BANKING DIAGRAM SHEET 8	PROJECT:	DOVER-STRATTON	PROJECT NO.:	STP 2214(I)S
	DESIGN FILE NAME:	/pave/99bi80/pbi80.dgn		
	IPARM FILE NAME:	pbi80bd08.i		
	SURVEYED BY:	CLD ENGINEERS, INC		
SQUAD LEADER:	WRH			PLOT DATE: 24-MAY-2007
				SURVEY DATE: 5/00
				DRAWN BY: PTS
				SHEET: 38 OF 49

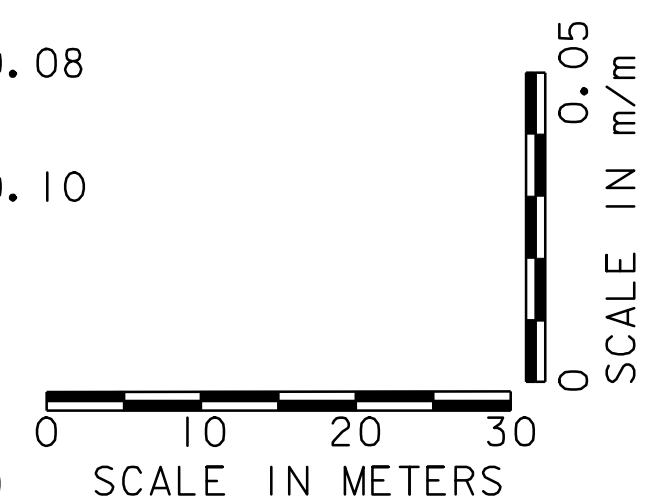
THE GRADES WERE ADJUSTED TO MEET FIELD CONDITIONS
